PEER REVIEW OF ACCIDENT SOURCE TERMS FOR LIGHT-WATER NUCLEAR POWER PLANTS USING HIGH-BURNUP AND MIXED OXIDE FUEL

PEER REVIEW OF ACCIDENT SOURCE TERMS FOR
LIGHT-WATER NUCLEAR POWER PLANTS USING
HIGH-BURNUP AND MIXED OXIDE FUEL

December 2011

Energy Research, Inc.
P.O. Box 2034
Rockville, Maryland 20847-2034

Cumulative Iodine Releases to Containment During the In-vessel Release Phase

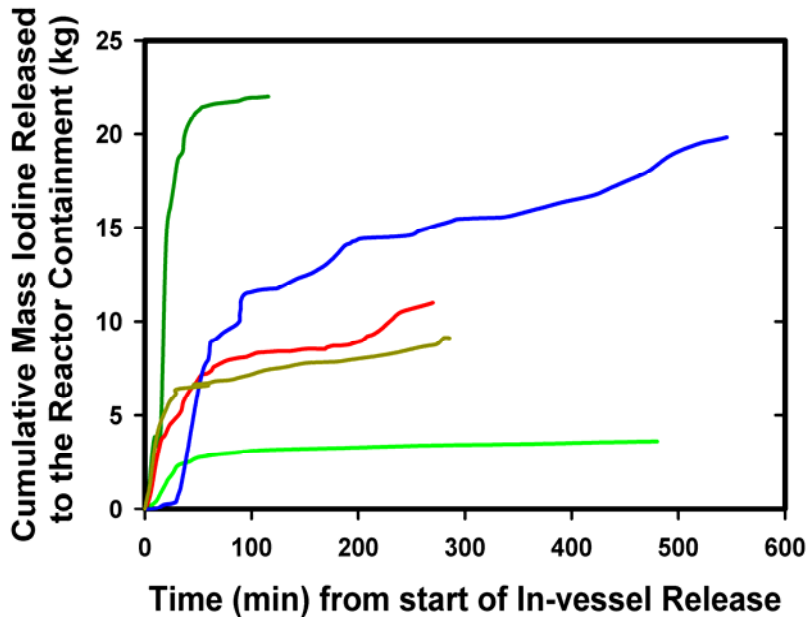
No decision has been made to divide in-vessel release into two stages. Expert opinions on the wisdom of retaining the assumption of a single phase with a constant release rate are solicited. At this juncture, it appears that in-vessel release could be divided into two phases each with a different but still constant release rate. No decision has been made to develop this alternative. Calculations to assess the impact of such a division of the in-vessel release phase on consequences would be a considerable expansion of the scope of this work and might take some time to accomplish. A crucial issue that will arise in dividing in-vessel release into two stages will be the criterion for ending the first and starting the second phase. Quite a range of behaviors was observed in calculations (See following slide showing single and multiple plateau and varying rates of initial and later release.) A clear-cut phenomenological basis for division of in-vessel release into two stages has not been identified. Consequently, whatever is selected will be viewed, in all likelihood, as arbitrary by some. Experts may want to offer their suggestions on a criterion if they feel it essential to segment in-vessel release into two phases.

Figure B.3.1 Measured FP gas release to the gap and plena of fuel rods

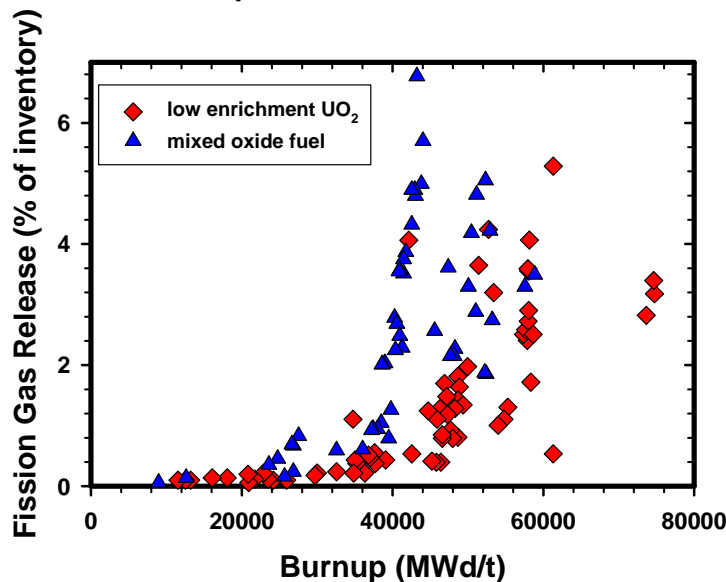
Interesting. It would be useful to obtain data for the puncture tests. We have access to data for PWR fuel shown in Figure B.3.1. It appears that variability in the gap inventory depends on both burnup and linear power rate. For the work under review, we attempted to control both at prototypic levels. It is also noteworthy that BWRs are going to fuel rods similar to those of PWRs as burnups are taken to higher levels. Currently, 10 x 10 BWR fuel assemblies are being used and there appears to be efforts to go to 14 x 14 arrays.

The given explanation for the gap release is quite logical. However, I am slightly concerned that the end of present gap phase or the initiation of in-vessel release is determined at the time of increase in release up to 5%. Since the present phase name, “gap release”, is closely related to the phenomenon, some people easily imagine that the FP release due to the cladding burst is equal to 5%.

Figure B.3.2 Distribution of concentration in grain and pores in pellet at elevated pressure [1]

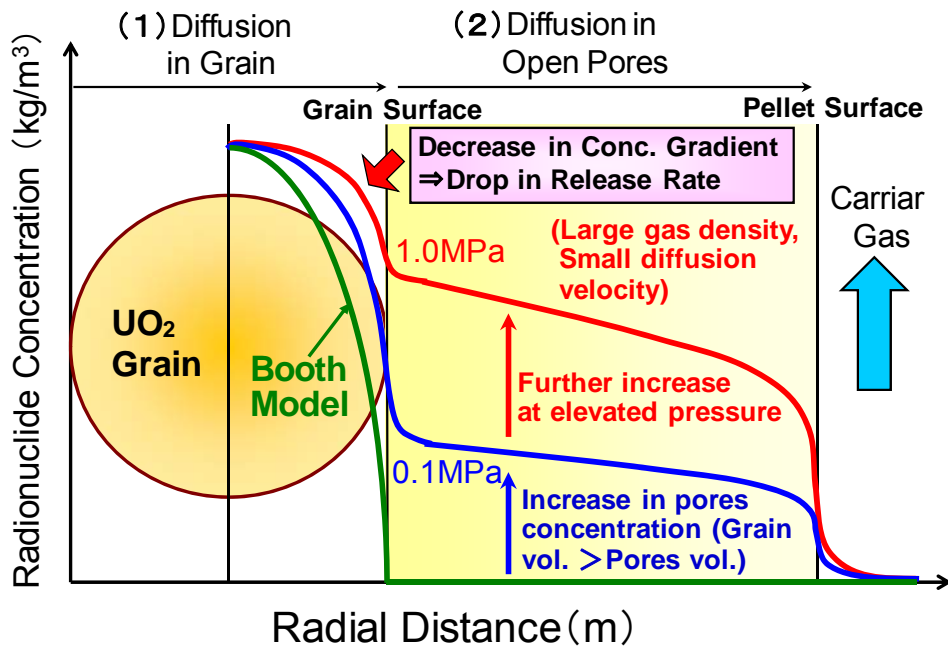
I consider that the pressure effect does not only depend on the Knudsen diffusion but also on increase in the concentration gradient in the grain. That is, the rate-determining step exists at both of diffusion in grain and pores. Expected distribution of radionuclide concentration in UO_2 grain and open pores in pellet at elevated pressure are shown in Figure B.3.2.

Figure B.3.3 Comparison of Cs release between measurements and 1/P^{0.5} CORSOR-M model [1]

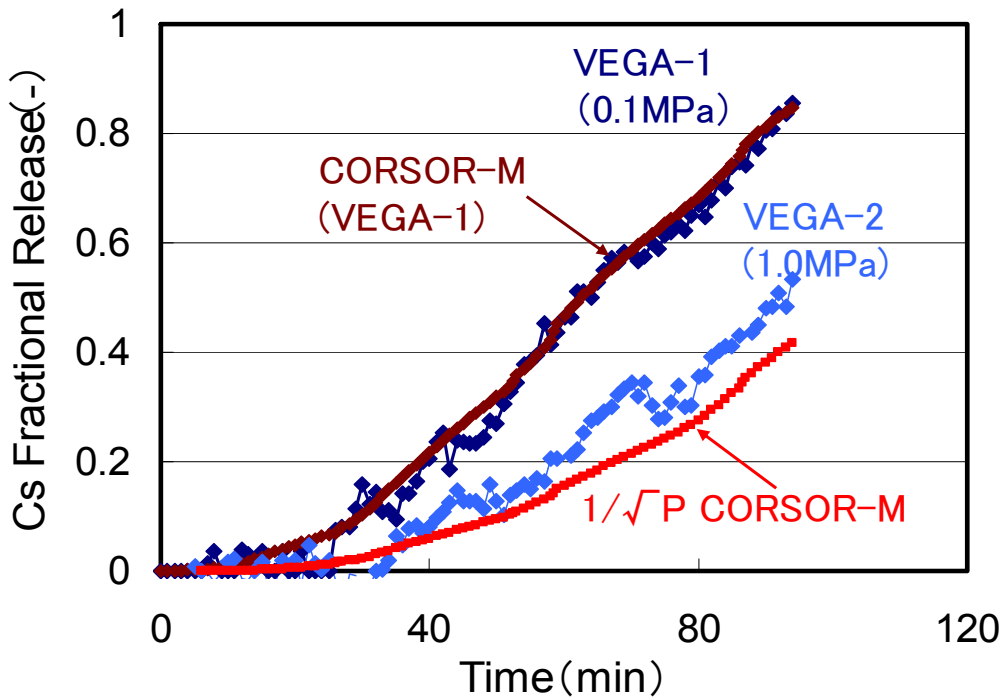
The elevated pressure could cause increase in gas density in open pores and decrease in gaseous diffusion velocity. These result in increase in radionuclide concentration in small-volume pores and at grain surface although the diffusion velocity in grain is much slower than that in open pores. The concentration increase at grain surface may suppress radionuclide release from grain because it decreases the concentration gradient in grain that is a driving force of diffusion. Consequently, the pressure dependence will not vary from the reciprocal of pressure to the reciprocal of the square root of pressure but vary from the reciprocal of smaller pressure dependence, for example, the cubic or fourth root of pressure, to the reciprocal of the square root of pressure. In reality, the pressure dependence with the reciprocal of the square root of pressure will slightly overestimate the observed pressure effect as shown in Figure B.3.3.

Figure B.3.4 Mo-O phase boundaries projected on the phase boundaries for U-O

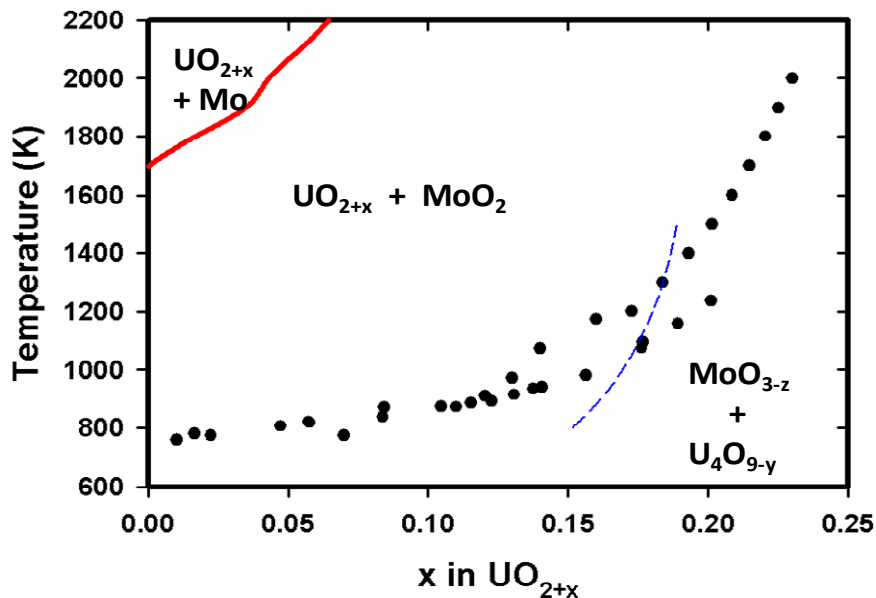
We have not been able to find experimental confirmation of the theoretical hypothesis that oxygen potential in irradiated MOX will be significantly higher than irradiated LEU. We believe that oxygen potentials in both fuels once they become hyperstoichiometric is buffered by the equilibrium:

where Mo is alloyed in nodules with Ru, Pd, Rh and other elements (see Figure B.3.4). The molybdenum dioxide product may or may not be soluble in the fuel lattice to an appreciable extent. The equilibrium is essentially the same for both types of fuel and so the oxygen potentials are about the same. Certainly, they are sufficiently similar that we are unable to find data that would provoke major changes in the modeling. It is hoped that further insights will be derived from the forthcoming VERDON experiments. We fully anticipate that results of these tests along with results from the VEGA tests will provoke improvements in the state of the art and, consequently, in the MELCOR modeling.

Figure B.3.6 Comparison of radionuclide release between VEGA-M1 and ORNL-Booth [3]

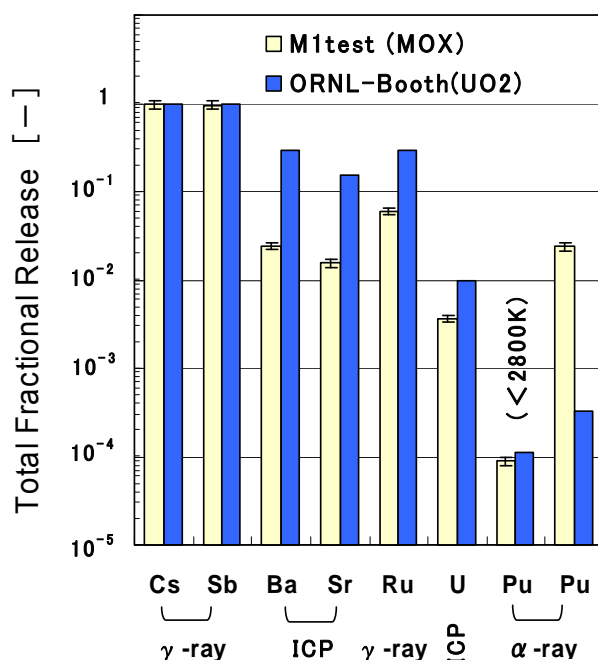
The release of Pu from MOX below 2,800K was predicted well by the conventional models such as ORNL-Booth while the release above 2,800K was enhanced and became larger by about one order of magnitude than that of the conventional models[3]. The existing models including the ORNL-Booth model underestimated it by about two orders of magnitude due to lack of experimental data at such high temperature as shown in Figure B.3.6. The enhancement of Pu release above 2800K was also observed in the VEGA-8 test with UO_2 fuel (see Table B.3.1).

However, it should be pointed out that the eutectic reaction could proceed too much in the VEGA geometry with crucible that maintains liquefied materials compared with the reality without crucible. The eutectic reaction is expected to be further examined in other future tests that simulate better the actual conditions during severe accidents.

Figure C.1 Release rate coefficients U and Pu in VEGA-M1 and VEGA-8 tests

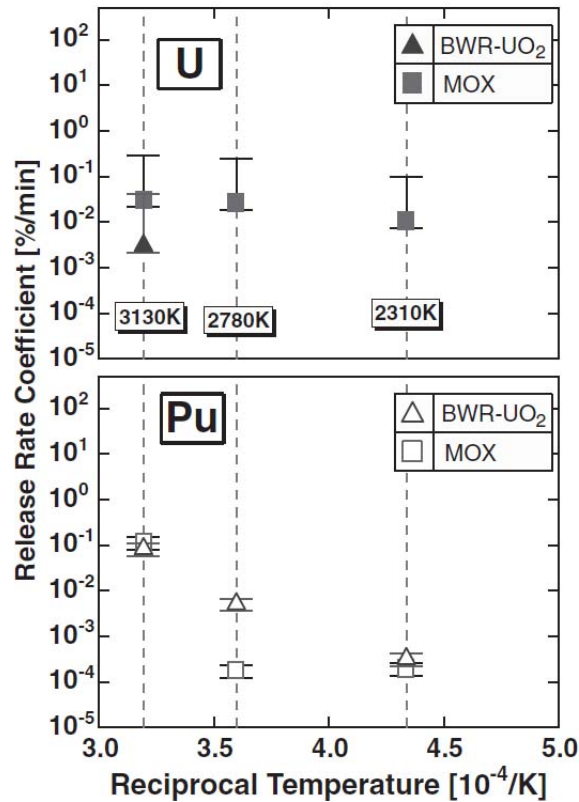
I looked at the experimental database to determine whether there was evidence that the values predicted by MELCOR might be too low. There are some measured releases of cerium or plutonium in the various small scale experiments that yield fairly large releases under reducing conditions. The strongest evidence is probably in the VEGA experiments as described by Dr. Hidaka. In Figure C.1 (Figure 9 from the VEGA report), the release rates measure at 2128K (melting point of Zr; lower bound on fuel melting) is 1E-4 %/min and at 2800K (50-50 ZrO₂/UO₂ eutectic temperature, which was the fuel collapse temperature used in MELCOR calculations) is 1E-3 %/min. At either of these rates, it would take less than a minute to exceed 1E-7 release fraction. I realize that these tests are always distorted in some respect and a direct comparison is questionable but it is evidence of a potentially larger release mechanism than modeled in MELCOR. From NUREG/CR–6261, an ORNL summary of release experiments, in the VI series releases from fuel were observed as shown in Table C.2.2. Of these the VI-5 release is the most surprising. Nevertheless, the other releases shown are also substantially larger than 1E-7.
